Title - Sujet IOS MCTS Renovation	
Solicitation No. - N° de l'invitation EZ899-211223/A	Amendment No. - N° modif. 001
Client Reference No. - N° de référence du client	Date 2020-10-30
GETS Reference No. - N° de référence de SEAG PW-\$PWY-043-8849	
File No. - N° de dossier PWY-0-43116 (043)	CCC No./N° CCC - FMS No./N° VME
Solicitation Closes - L'invitation prend fin at - à 02:00 PM on - le 2020-11-10	
Time Zone Fuseau horaire Pacific Standard Time PST	
F.O.B. - F.A.B. Plant-Usine: <input type="checkbox"/> Destination: <input checked="" type="checkbox"/> Other-Autre: <input type="checkbox"/>	
Address Enquiries to: - Adresser toutes questions à: Dumay (PWY), Clara	Buyer Id - Id de l'acheteur pwy043
Telephone No. - N° de téléphone (604) 499-9708 ()	FAX No. - N° de FAX () -
Destination - of Goods, Services, and Construction: Destination - des biens, services et construction: DFO – Institute of Ocean Science – Sidney, BC

This Amendment 001 is raised to incorporate Addendum No. 1.

1.0 ARCHITECTURAL/GENERAL

Photos for reference

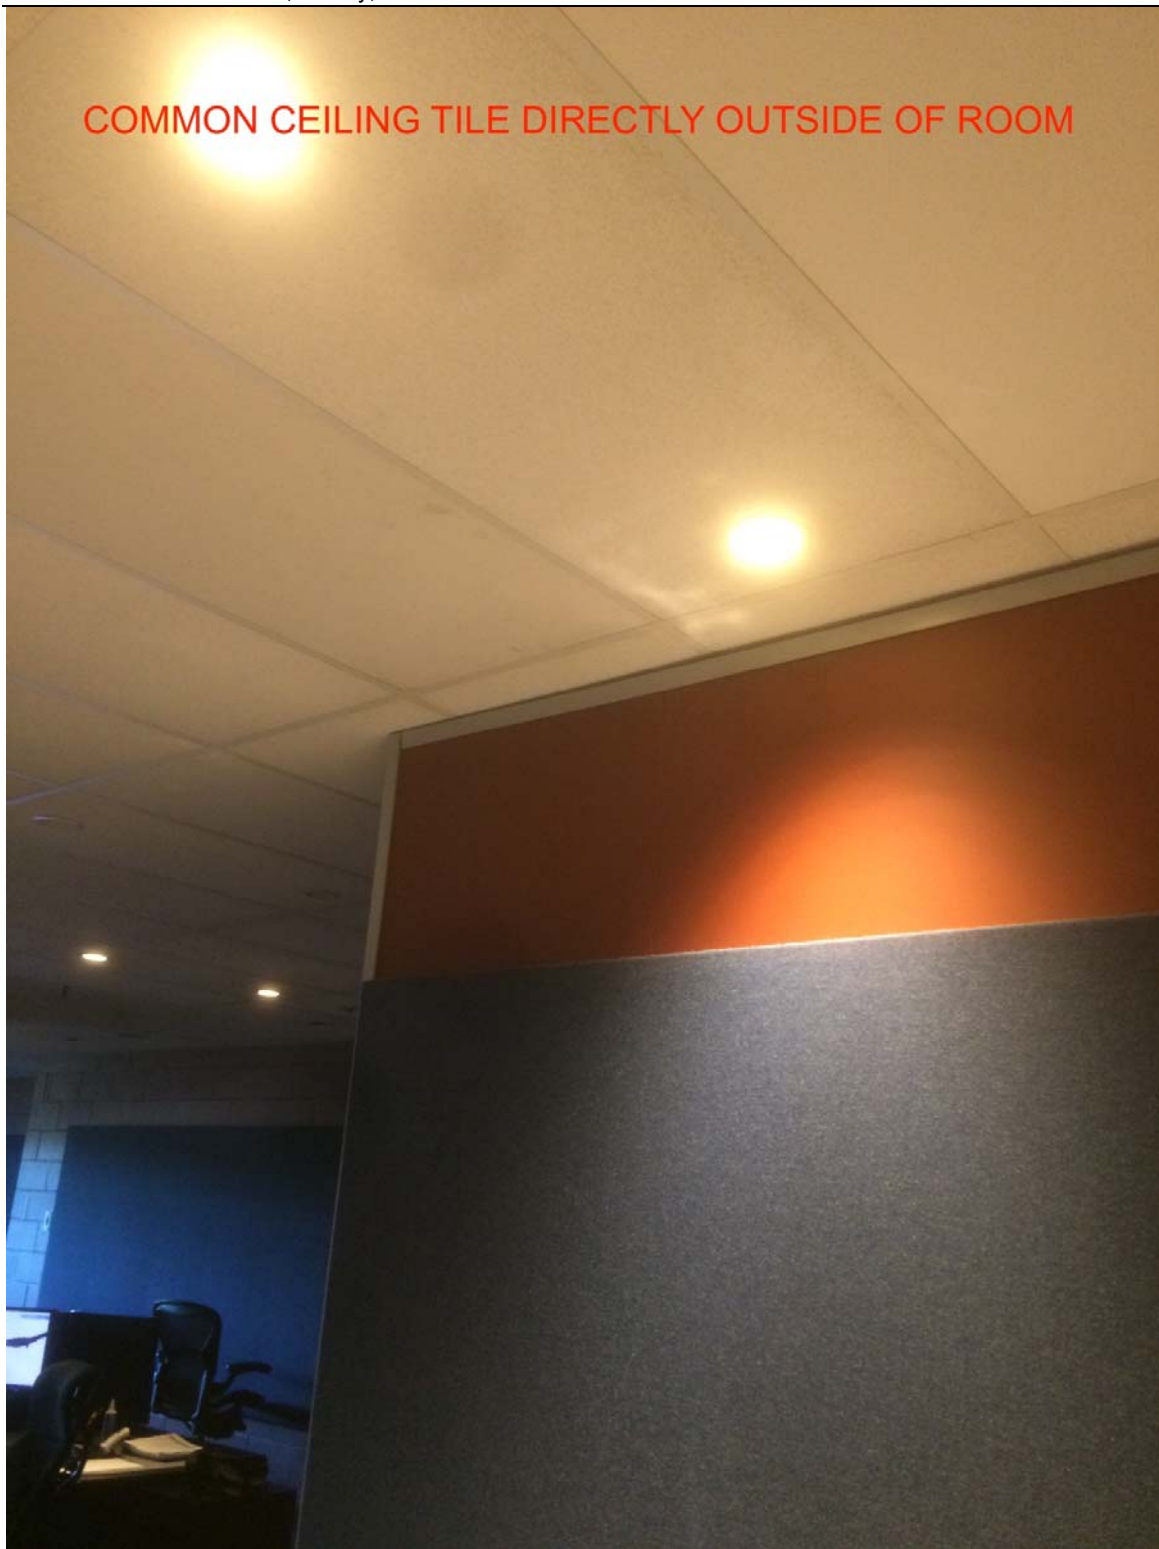
- .5 Please confirm whether the HVAC ducting demo shown in detail 1/M1.00 is under the existing access flooring or above the t-bar.

- .6 If the demo is under the access floor, please advise whether the flooring is being replaced in this area.

- .7 If the demo is above the t-bar, please advise whether the t-bar grid is to be replaced in this area.

- .8 For the relocated floor grilles shown on detail 2/M1.00 between gridlines E and F along gridline 2.5, please confirm where these ducts are being fed from. The same question applies to the grille shown at gridline D"/1.6. There doesn't appear to be an HVAC duct branch shown that feeds these locations.

RESPONSE: Demo is above the t-bar.

RESPONSE: Refer to .5 above.

RESPONSE: T-bar is to be removed and reinstated.

RESPONSE: The floor grilles to be relocated and added are utilizing the floor plenum and therefore no duct connections required for these grilles.
